ORIGINATION FORM

Proposed Revisions to a Standard Plans Index
(Please provide all information — Incomplete forms will be returned)

Index Number: 102-615
Sheet Number (s): 1 and 4 of 5
Index Title: Multilane Roadway, Intersection Work

LAST REVISION 11/01/21	REVISION	DESCRIPTION:		FY 2022-23 STANDARD PLANS	MULTILANE ROADWAY, INTERSECTION WORK	INDEX 102-615	SHEET 4 of 5
---------------------------	----------	--------------	--	------------------------------	--------------------------------------	------------------	-----------------

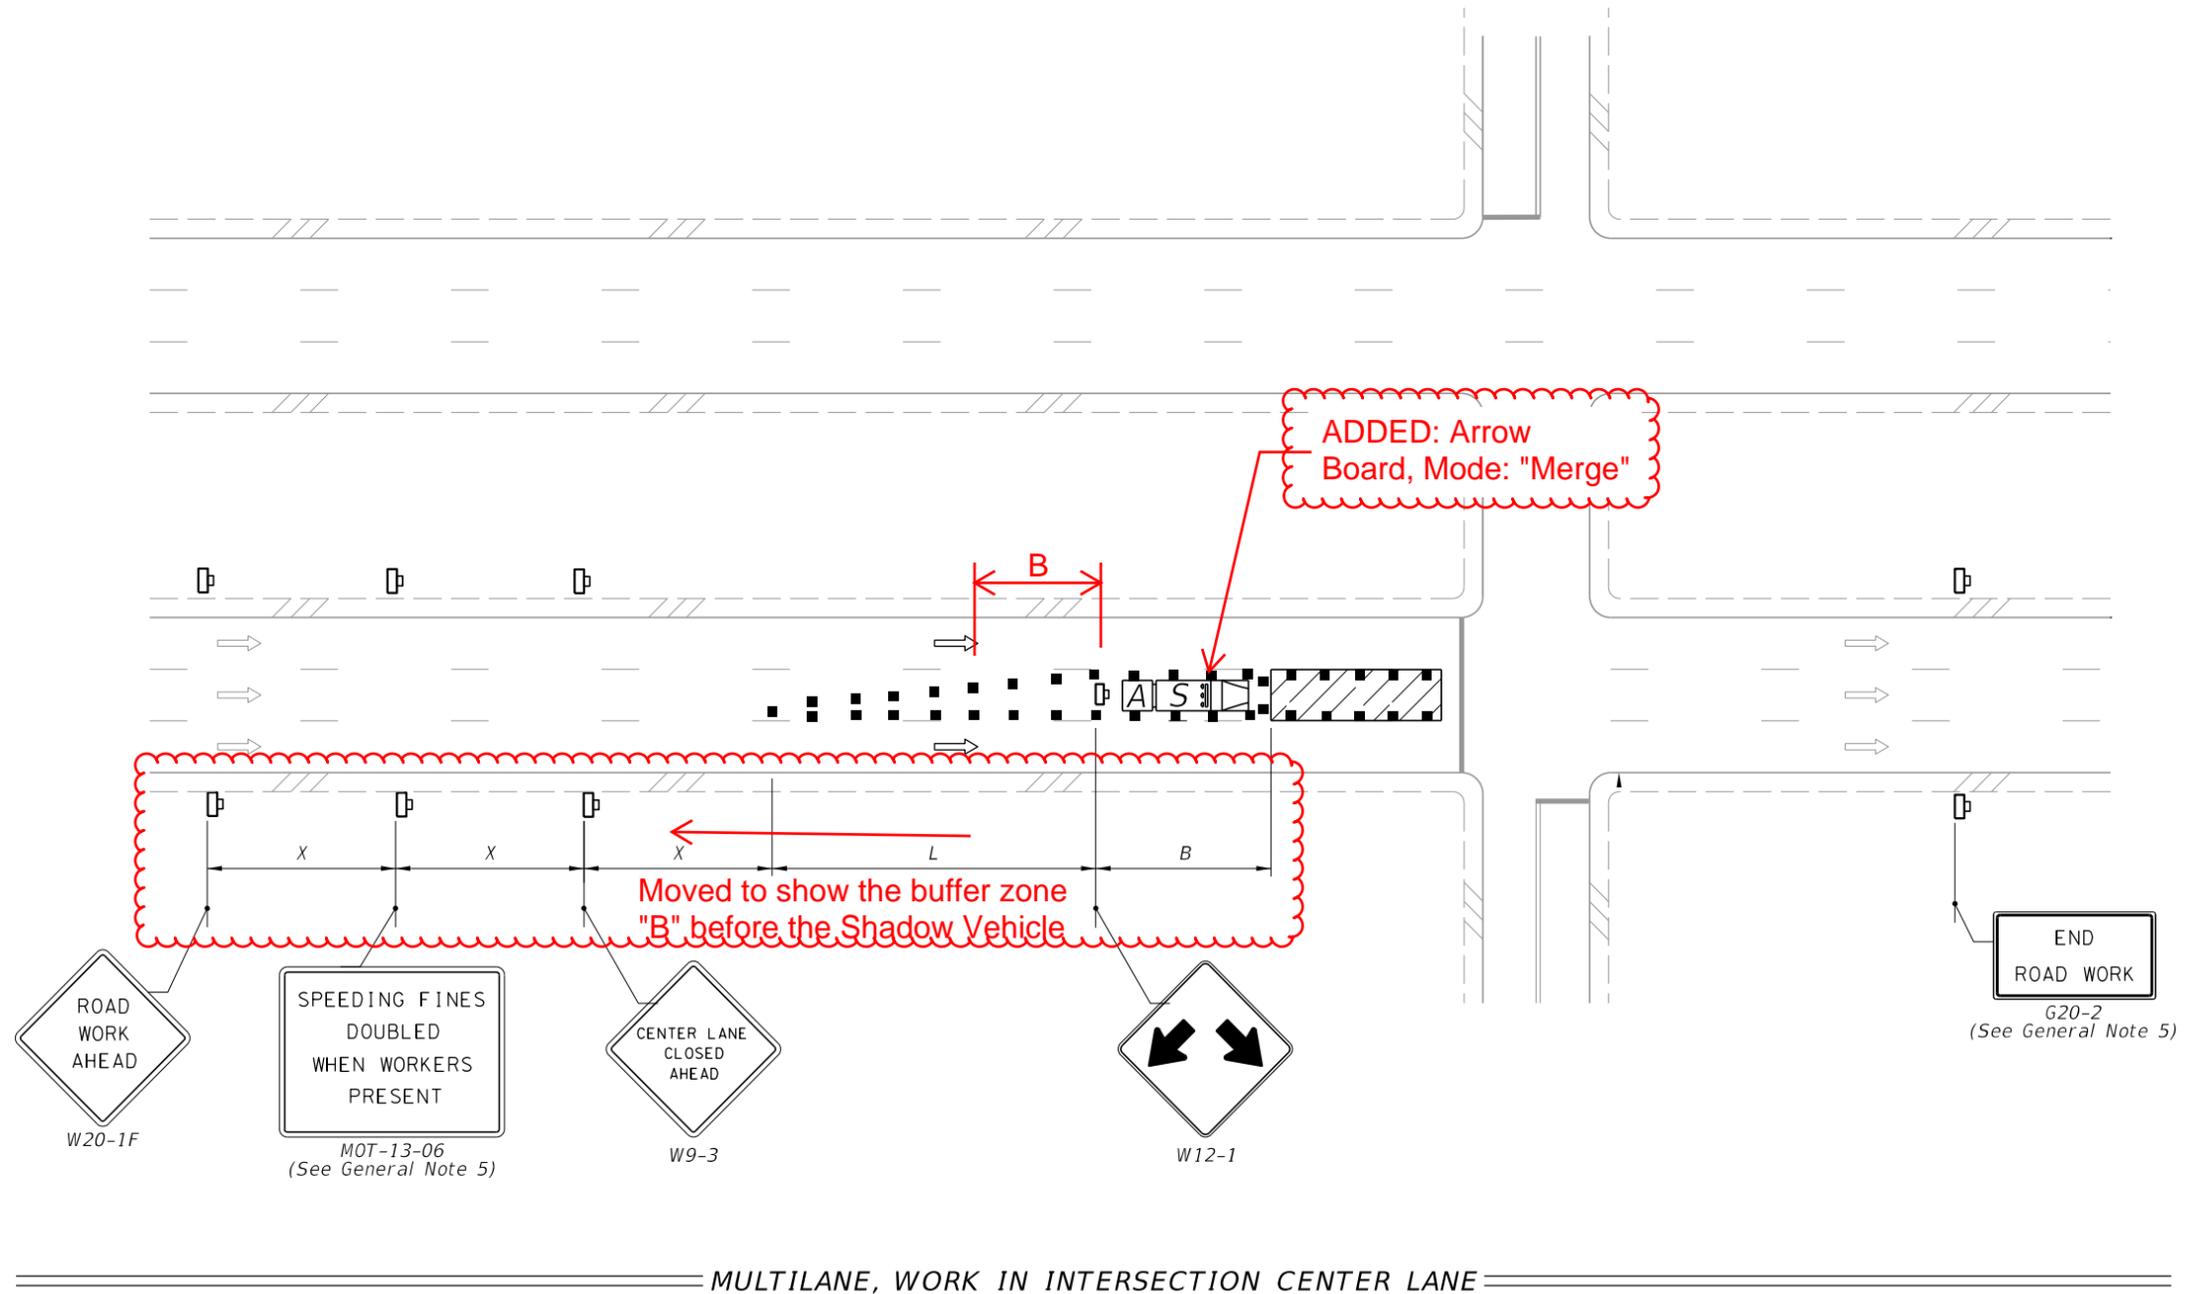
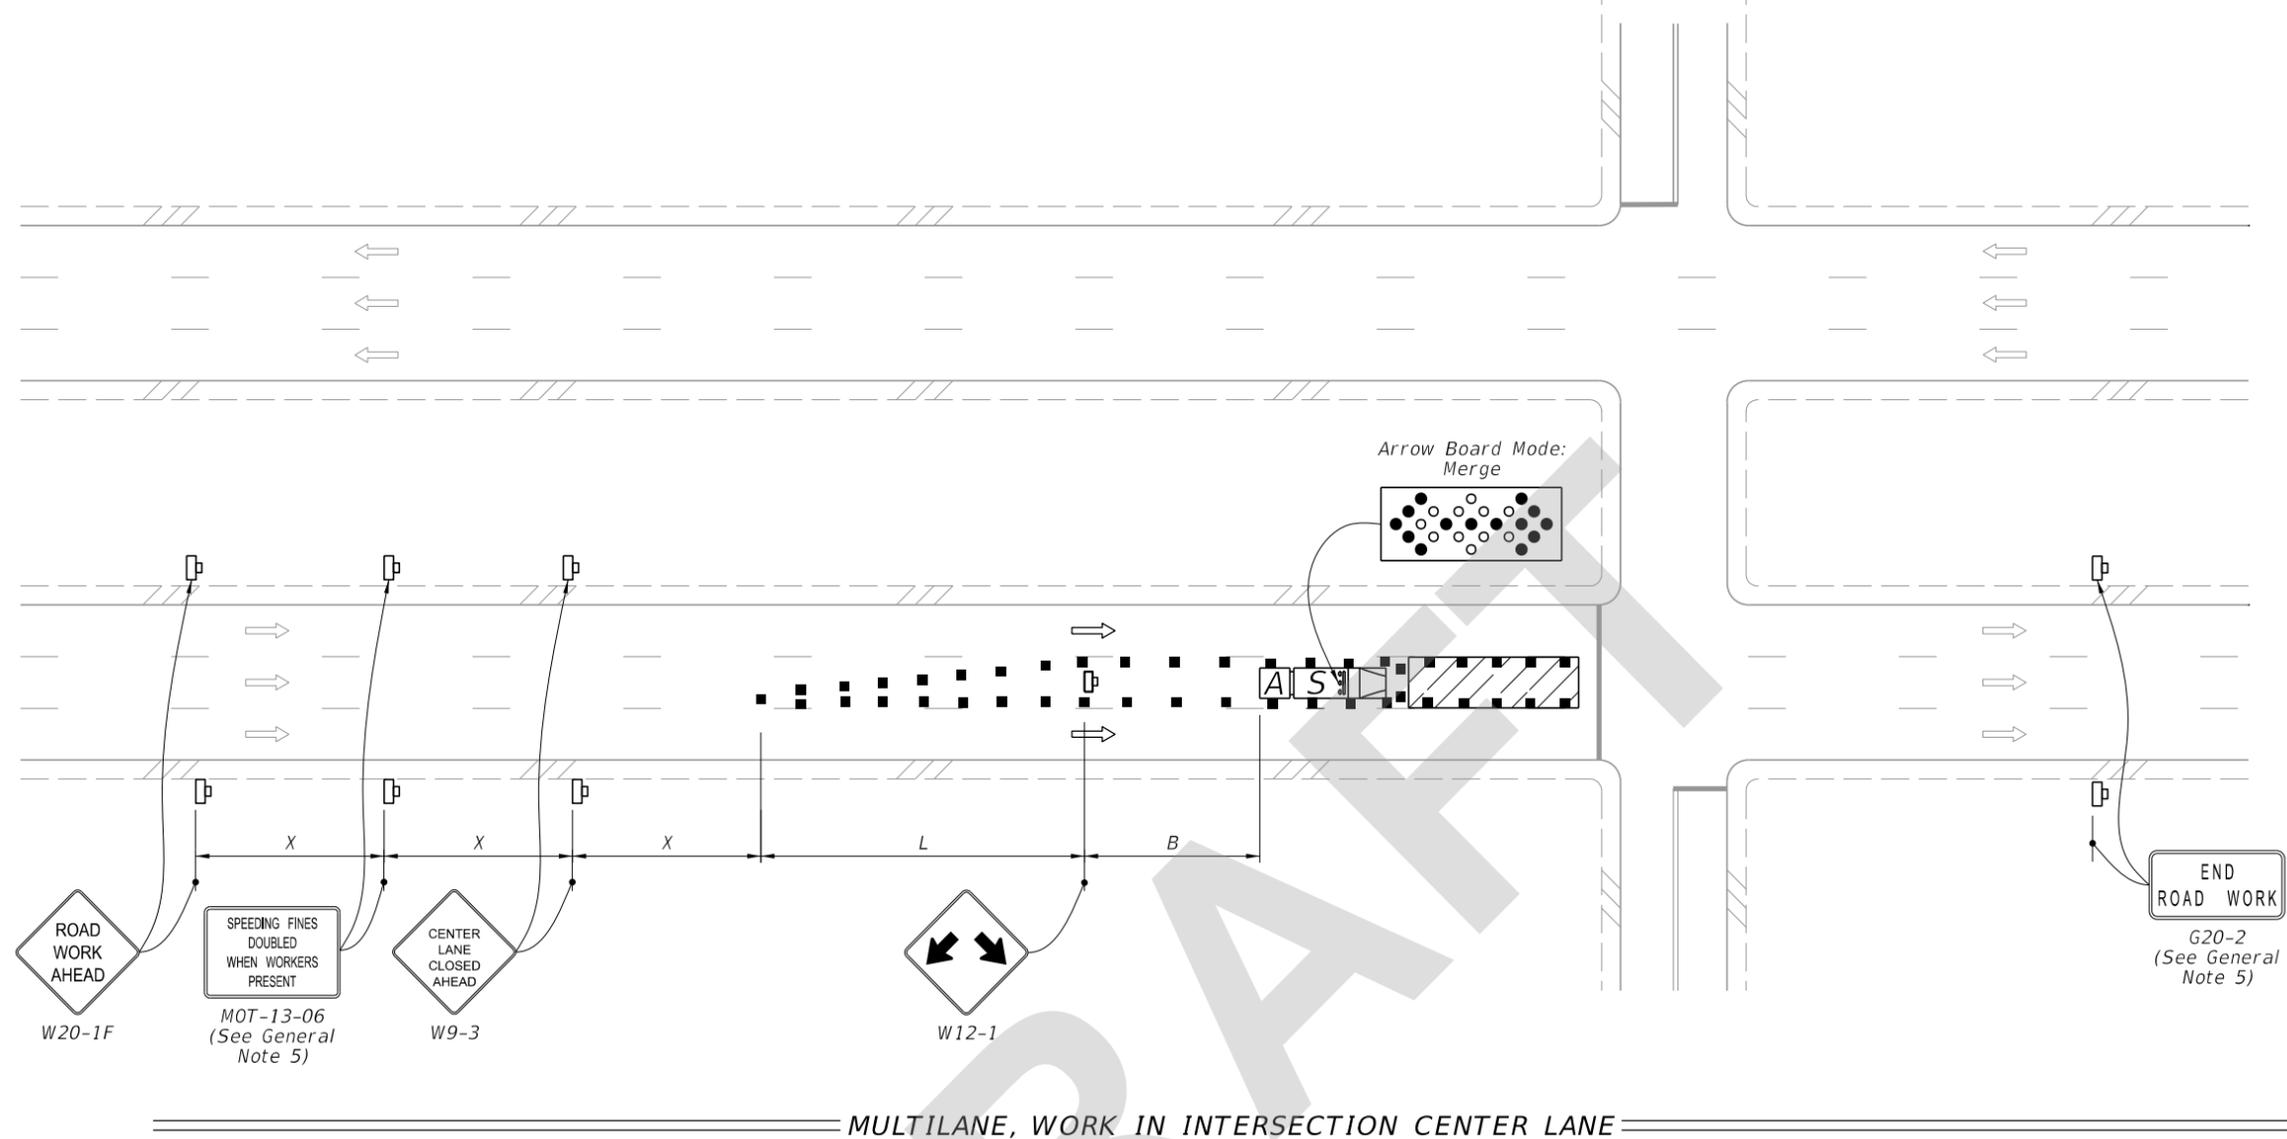
Sheet 4: Moved buffer zone and the associated dimension "B" before the Truck Mounted Attenuator in the work zone.

The buffer space was moved to be consistent with the MUTCD. MUTCD guidance says "When a shadow vehicle, arrow board, or changeable message sign is placed in a closed lane in advance of a work space, only the area upstream of the vehicle, arrow board, or changeable message sign constitutes the buffer space."
